Application Serial No. 09/771,471  
Customer No.: 26021  
Reply to Office Action Dated August 24, 2004

PATENT  
1892-174 (81841.0044)

Application Serial No. 09/771,471  
Amendment dated 11/17/04  
Reply to Office Action dated 08/24/04  
Annotated Sheet Showing Changes

Figure 2

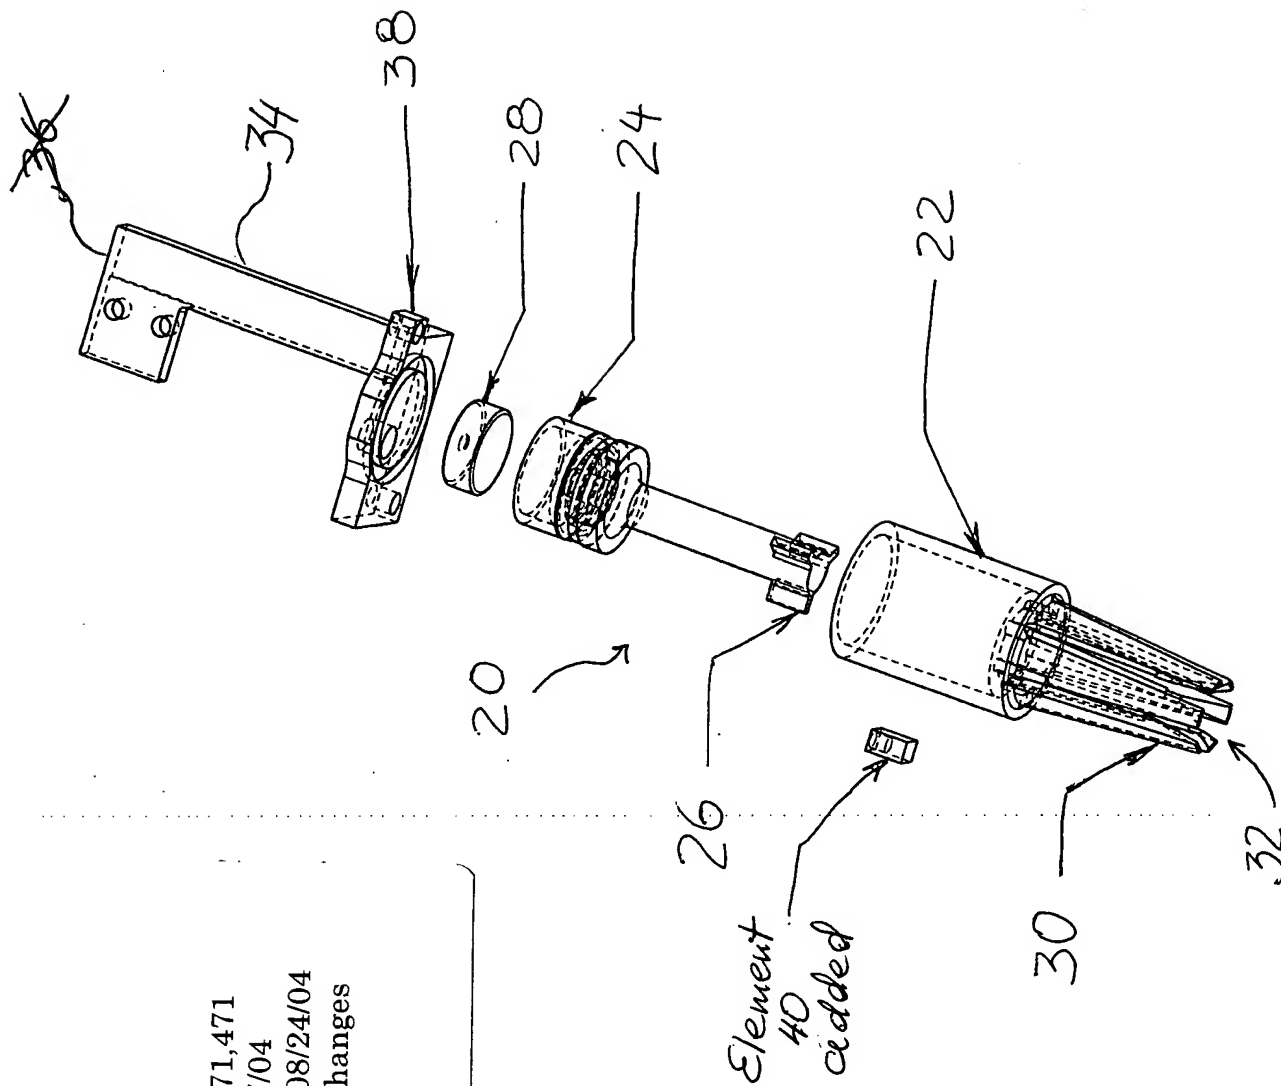
The drawings were objected for not showing adapter recited in claim 2 and sensor recited in claim 9. The adapter was shown in the original Figure 2 (reference numeral 34) but was not referred to by its reference numeral in the specification. Applicants amended the specification as shown above to add reference numeral 34 to the description of the adapter.

Thus, according to 37 CFR 1.83, the sensor of the present invention should be illustrated in the drawing in the form of a graphical drawing symbol or a labeled representation (e.g., a labeled rectangular box). Accordingly, applicants added such a schematic representation of the sensor 40 to Figure 2 and amended the specification as shown above to provide a proper reference to the sensor. These amendments overcome Examiner's rejections of the drawings. Corrected drawing sheet in compliance with 37 CFR 1.121(d) is attached.

The attached sheet of drawings includes changes to Fig. 2 and replaces the original sheet including Fig. 2. In Figure2, previously omitted element 40 has been added. Also, the reference numeral 36 that is not used in the specification has been deleted.
